Public Comment No. 1392-NFPA 70-2021 [Global Input]

Modifications to Article 245. See attached Word document

Statement of Problem and Substantiation for Public Comment

**FIGURES 1-4: LARGE PERCENTAGE OF HOME IMPROVEMENTS DONE BY DIY'ers;
"PROFESSIONALS" CAN INCLUDE PAINTERS AND HANDYMEN, NOT ALWAYS ELECTRICIANS.**

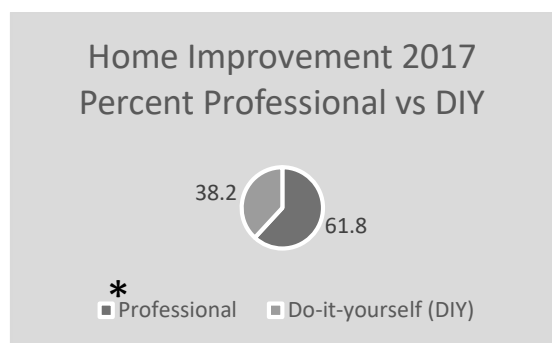
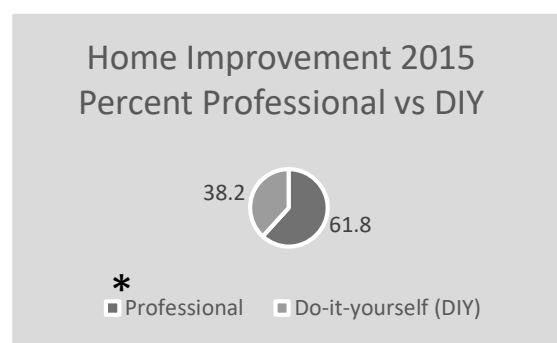
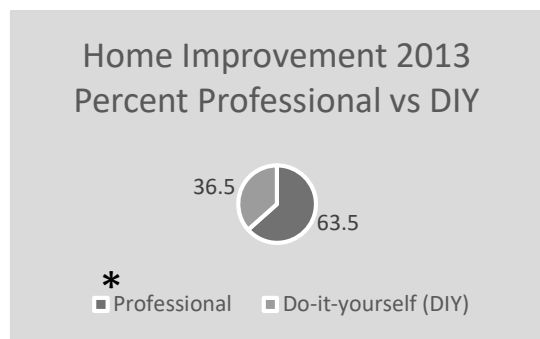
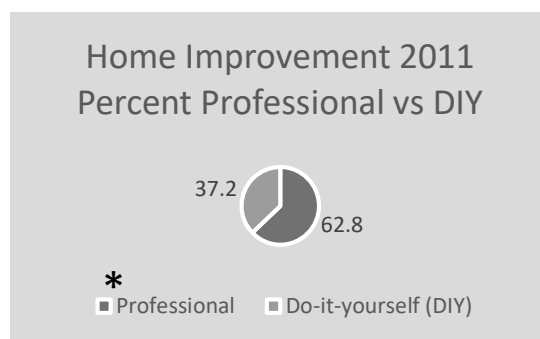
performed by the homeowner. Surprisingly, the statistics also show a fairly consistent percentage of electrical renovations that are DIY. Permits are rarely taken out for DIY equipment replacements or renovations. That is sometimes the case with flipped homes. As a result, DIY work is rarely inspected by jurisdictional electrical inspectors. Even when permits are taken out, there is no guarantee that the work will be performed by professionals or that it will be inspected. Many jurisdictions will only spot check the work of homeowners because inspections cost money and if there is no inspection, the jurisdiction can just collect the permit fee. For those who are classified as professional, how many of the practitioners are electricians? How many are just handymen? Figures 1 through 4 illustrate the percentages of home improvement projects for a two-year period ending in 2017, 2015, 2013, and 2011. Figure 5 illustrates all of the electrical home improvement projects reported by the survey from 2010 through 2017. The background data is in Annex A.

Figure 5.

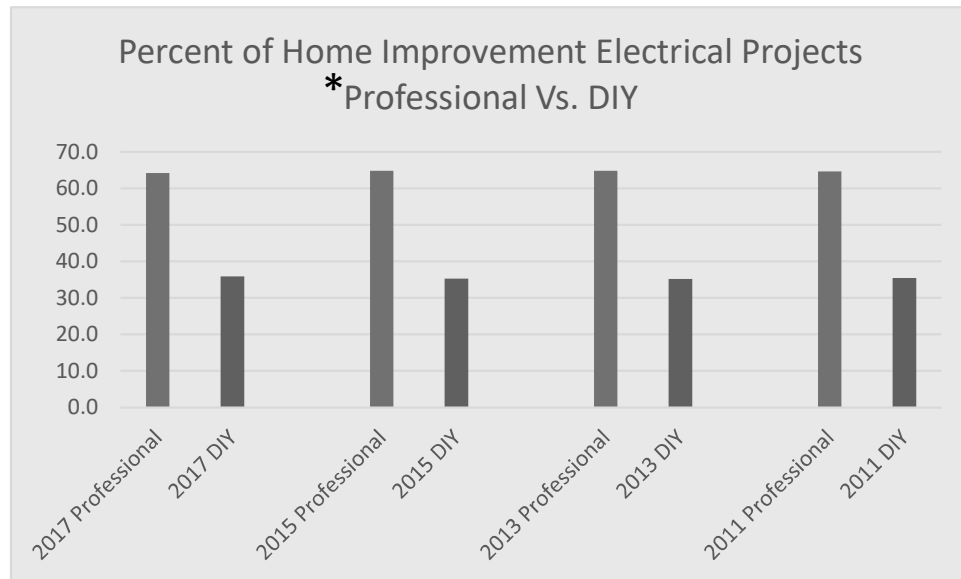
The number of people who are willing to do electrical work themselves has been a similar percentage to that of all DIY projects. It has also remained steady over the study periods of the survey. The raw statistics are included to provide a clearer picture of the types of home improvement projects undertaken. Many of the interior renovations likely include some electrical work, which may or may not be included separately as electrical work.
